# Technical Service Information

## SATURN TAAT DELAYED AND OR NO REVERSE

Figure 1

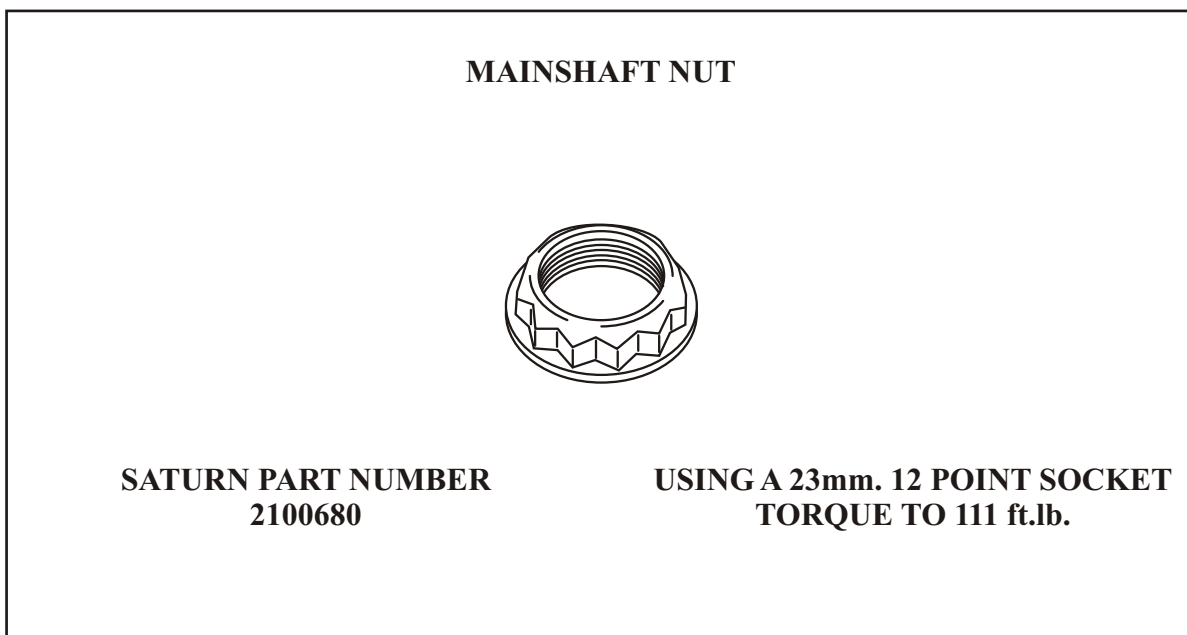
**CAUSE:** The cause may be, a loose Mainshaft Nut, as shown in Figure 1, causing a leak in the 2nd clutch circuit. When the nut loosens the mainshaft tends to walk back and forth in the mid case. This causes a gap between the 1st Clutch and the nut, which is where the leak in the 2nd Clutch circuit appears. In Figure 2 the cutaway shows how the 2nd Clutch is fed around the outside of the feed pipe for the 3rd clutch. **Notice** that the area over and under the nut are all part of the 2nd Clutch circuit.

**CORRECTION:** Install a new Mainshaft nut, which has a factory thread locker, as part of every repair. Using a 23mm. 12 point socket torque the new nut to 111 ft.lb.
